# ADDENDUM NO. 2

**August 3, 2026**

## **MERRILLVILLE HS CULINARY AND MEETING AREA RENOVATIONS AND MERRILLVILLE CSC CENTRAL OFFICE ADDITION AND RENOVATION PROJECT**

**Addendum Two (AD.02)** to the drawings and specifications prepared by Gibraltar Design for **Merrillville HS Culinary and Meeting Area Renovations and Merrillville CSC Central Office Addition and Renovation** for Merrillville Community School Corporation, Merrillville, Indiana.

## UNIT "T" ELECTRICAL FIRST FLOOR DEMOLITION PLAN

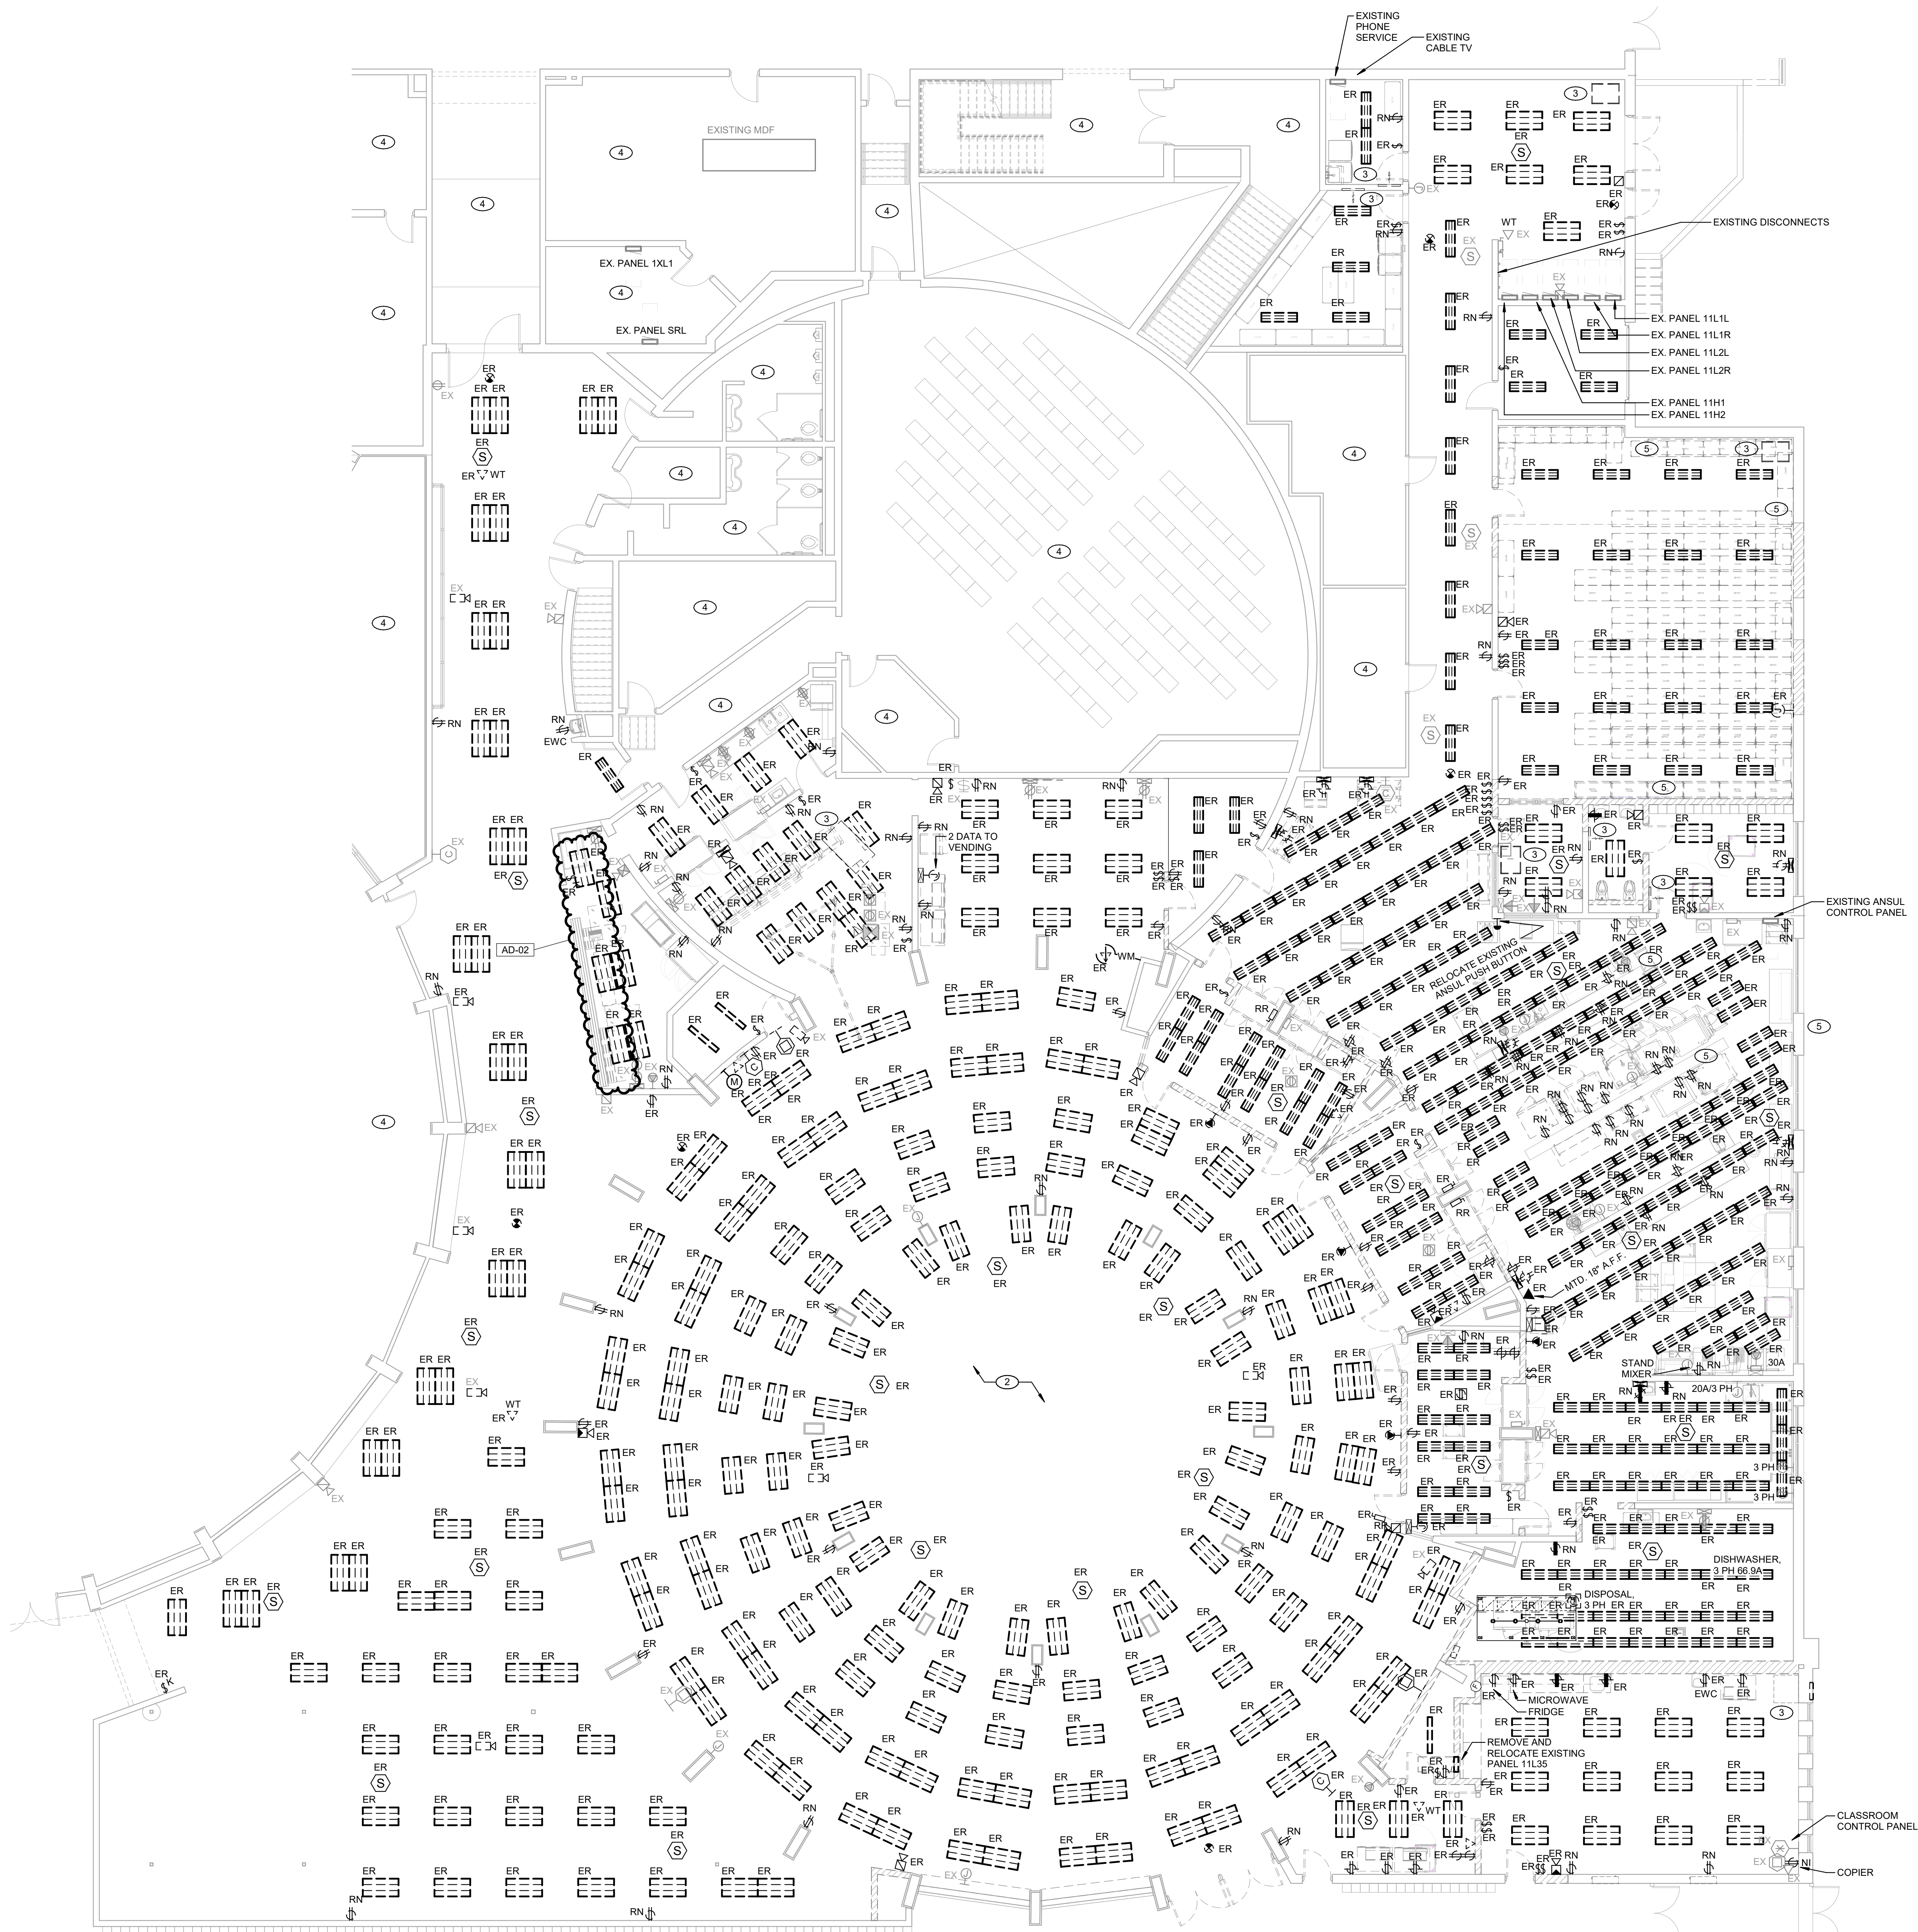
- A. Refer to revised, full-size drawing, included in this Addendum, for revisions.
  - 1. Removed existing floor boxes from the floor plans in the pirate's cove area.

# UNIT "T" ELECTRICAL POWER FIRST FLOOR PLAN

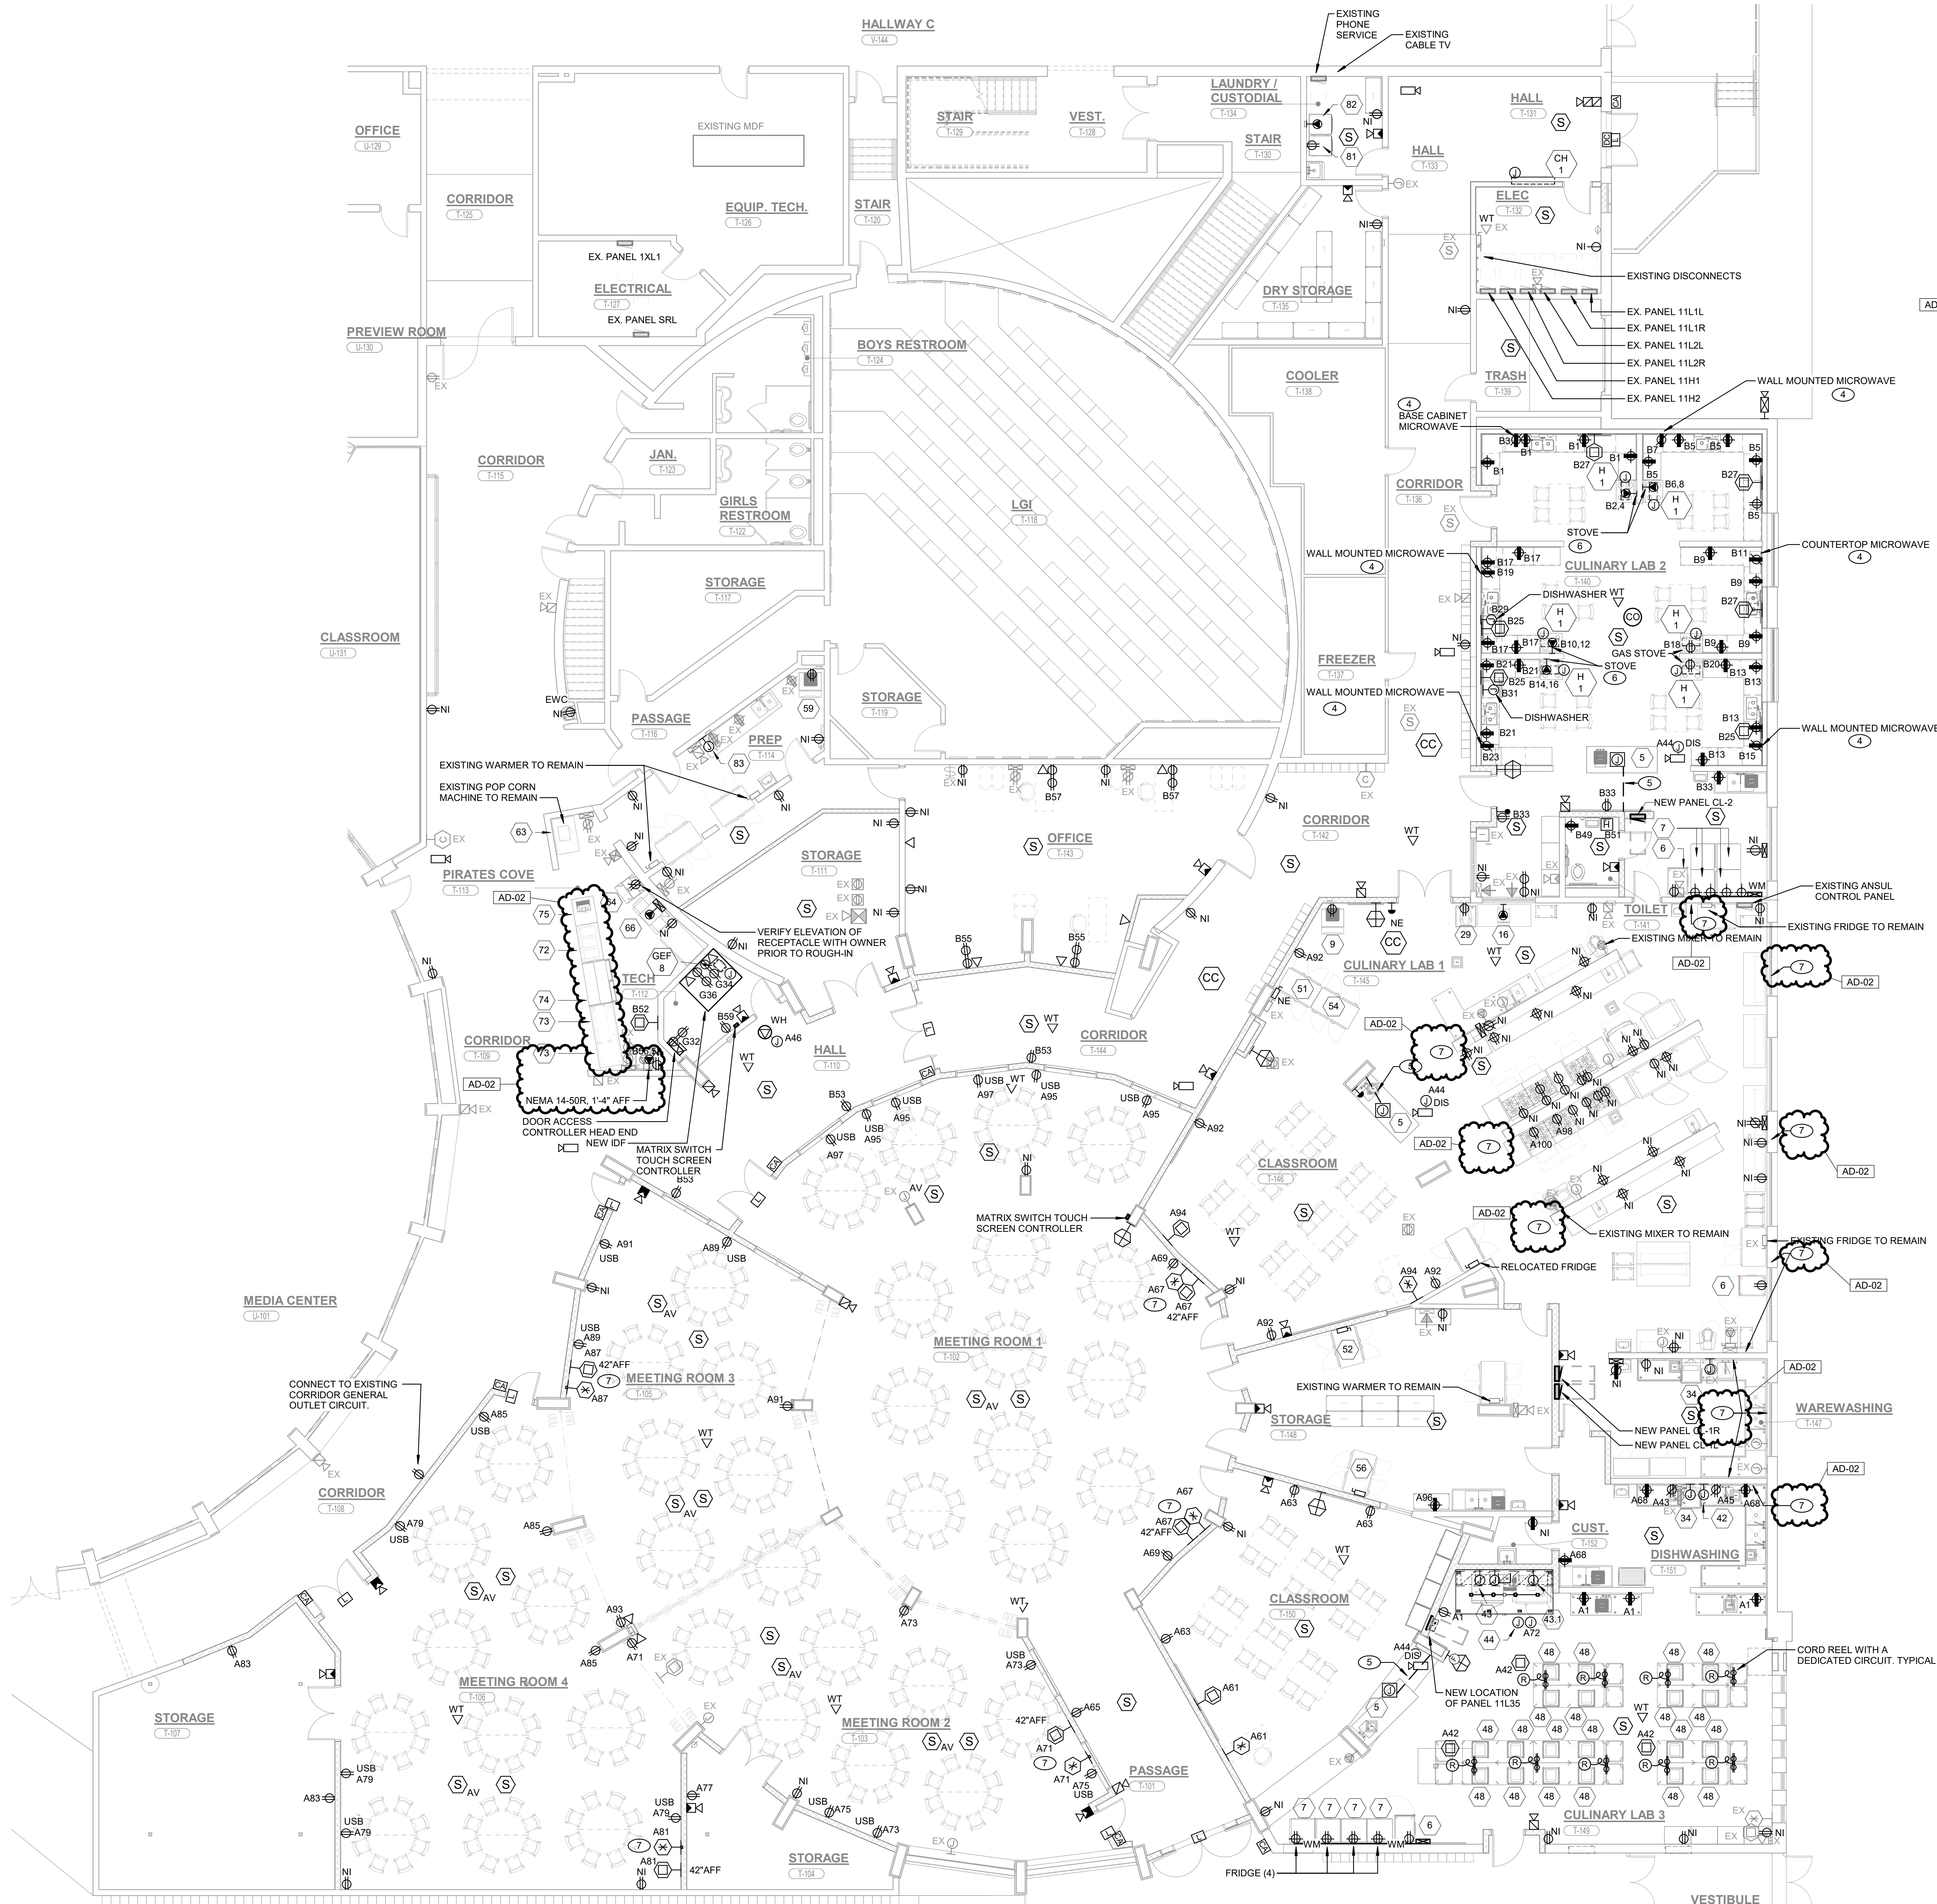
- A. Refer to revised, full-size drawing, included in this Addendum, for revisions.
  - 1. Added sheet note #7.
  - 2. Removed floor boxes from Pirate's Cove.
  - 3. Updated electrical connections for the equipment on the west side of pirate's cove.

DRAWING  
FOUNDATION PLAN

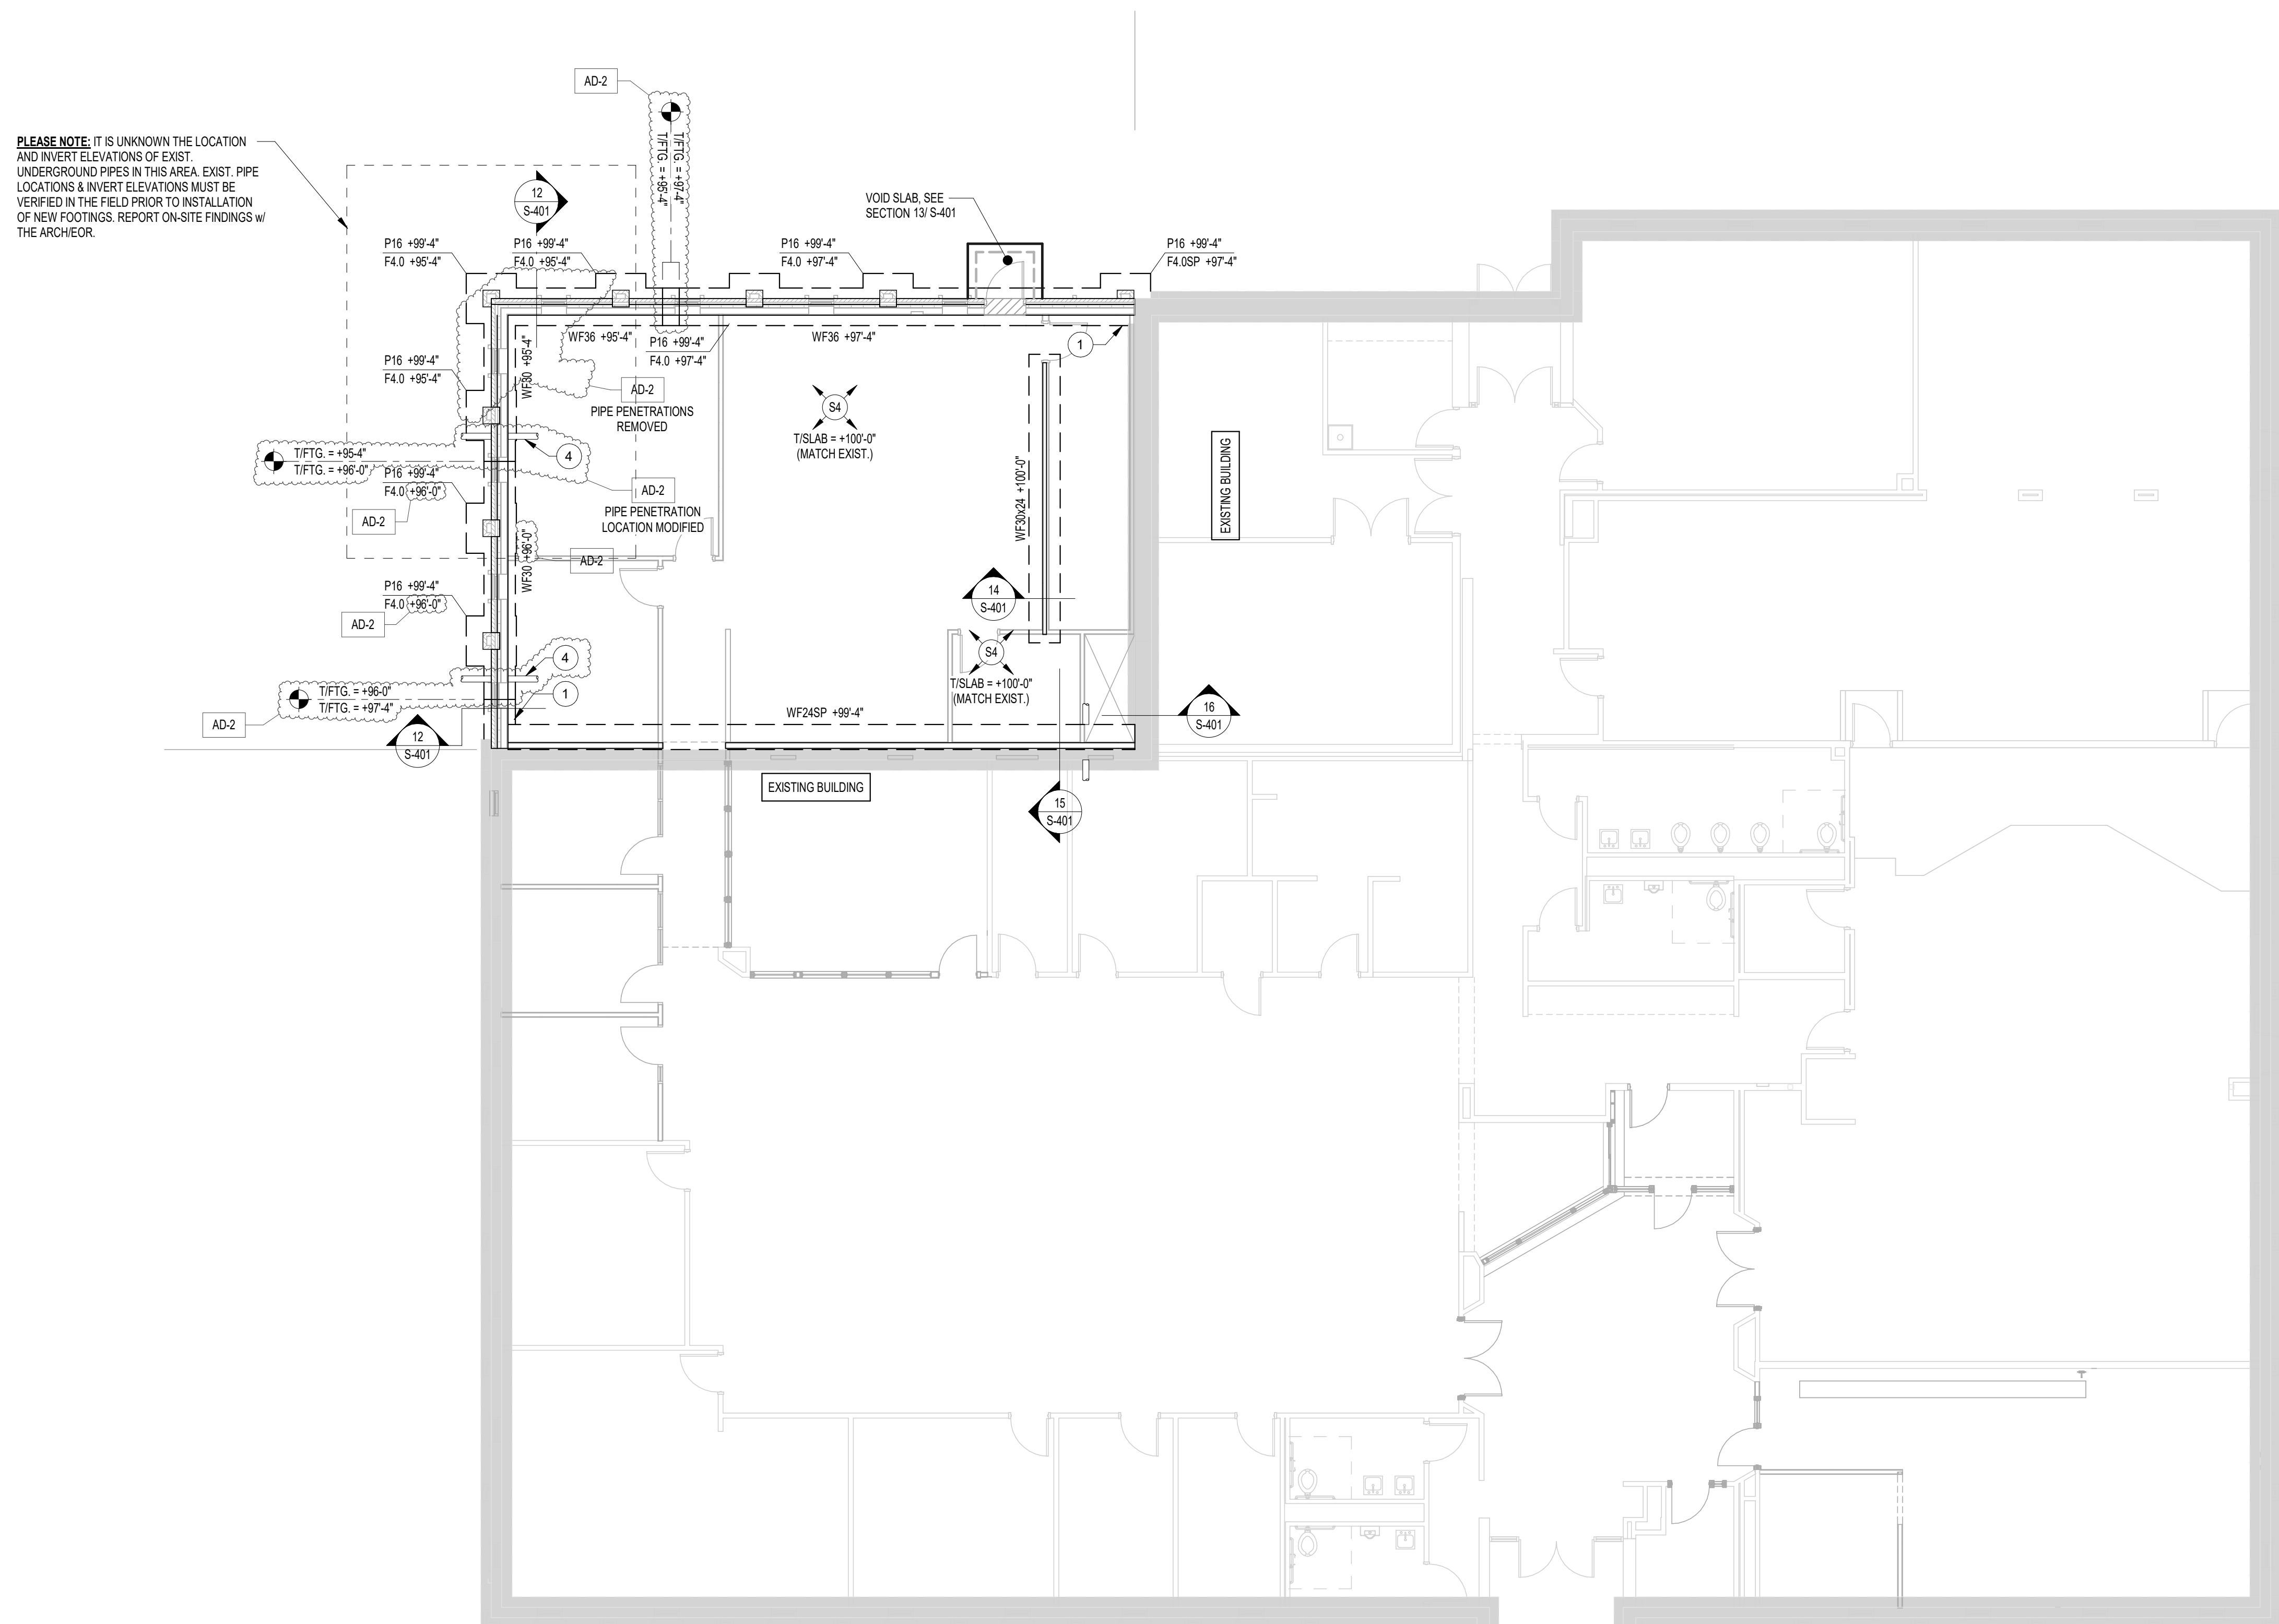
- A. Refer to revised, full-size drawing, included in this Addendum, for revisions.
  - 1. Foundation Wall Pipe Penetrations Removed, Relocated and added.
  - 2. Top of footing elevations adjusted.
  - 3. Stepped footing callouts added.
  - 4. Steel Column Reference on the foundation plan notes removed.
